ADDENDUM NUMBER ONE (1)

Date: August 18, 2026

Project Name: Workforce Development Center
Leake County
Frontage Road
Carthage, Mississippi 39051

CCD Project: 25005

DRAWING NUMBER
C4.0 R1

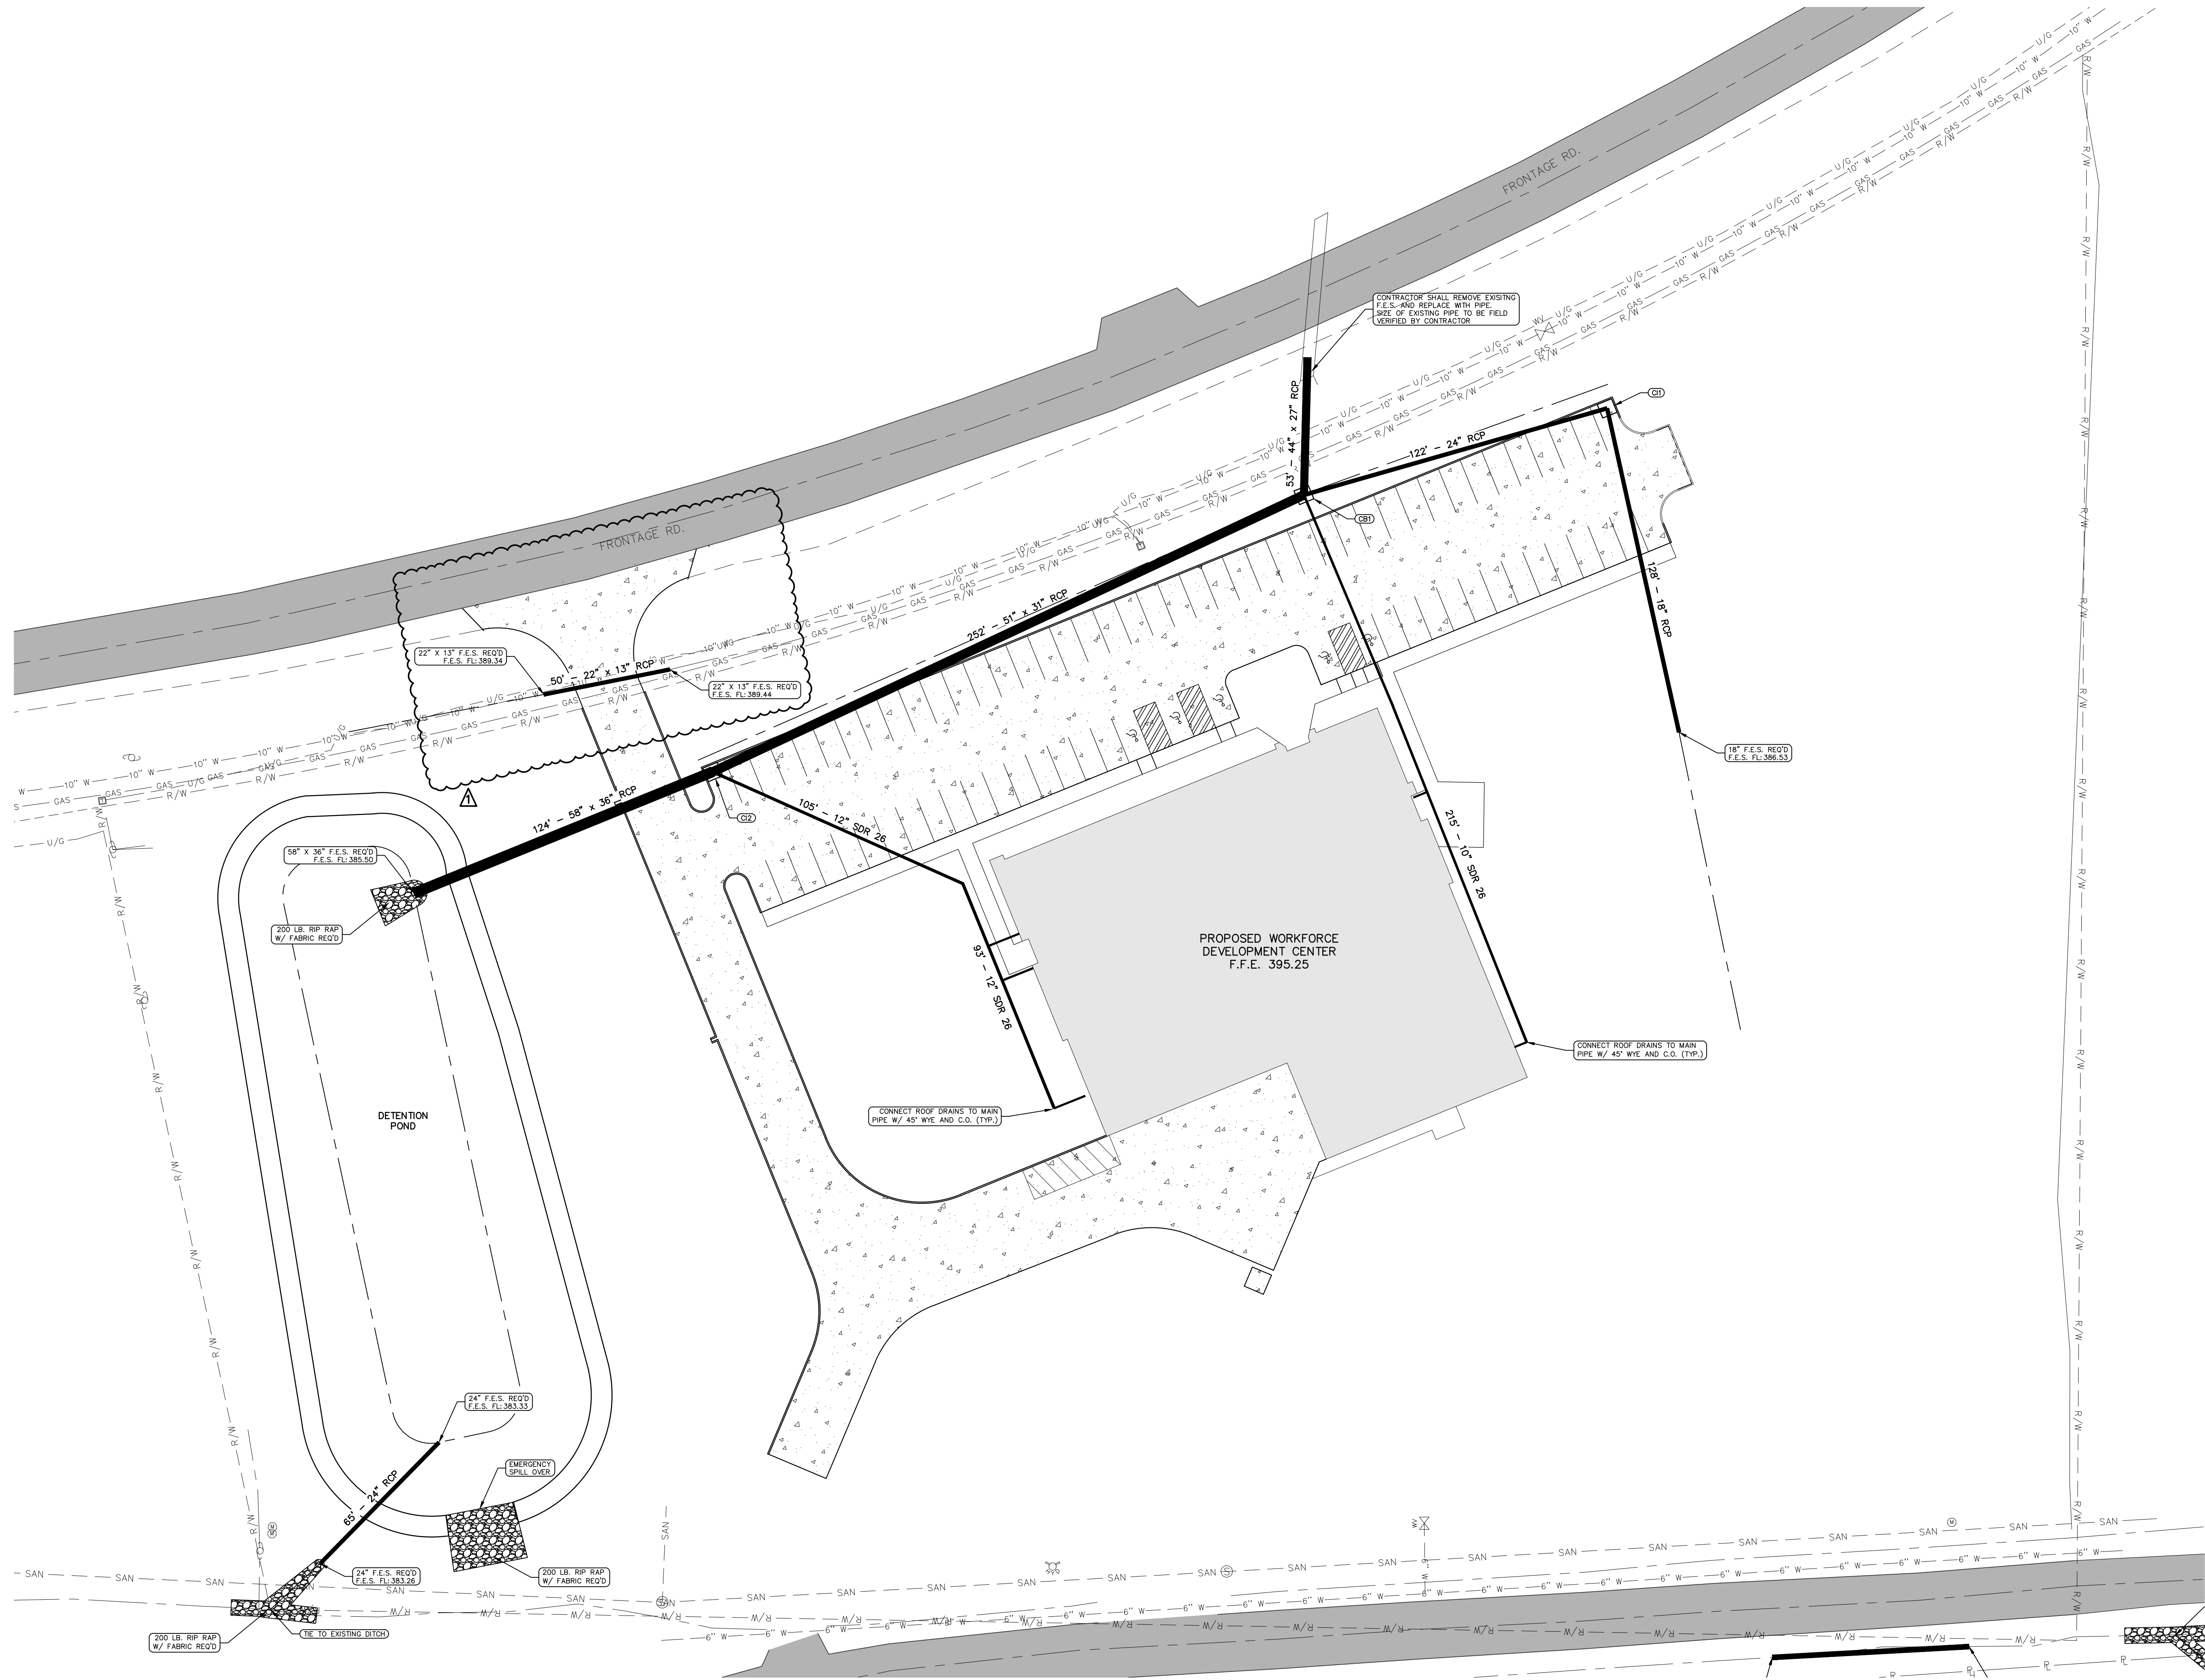
- 1.7 **C4 GRADING PLAN:** Replace with attached C4 R1 dated as revised August 18, 2026.
- 1.8 **C6 STORM DRAIN PLAN:** Replace with attached C6 R1 dated as revised August 18, 2026.
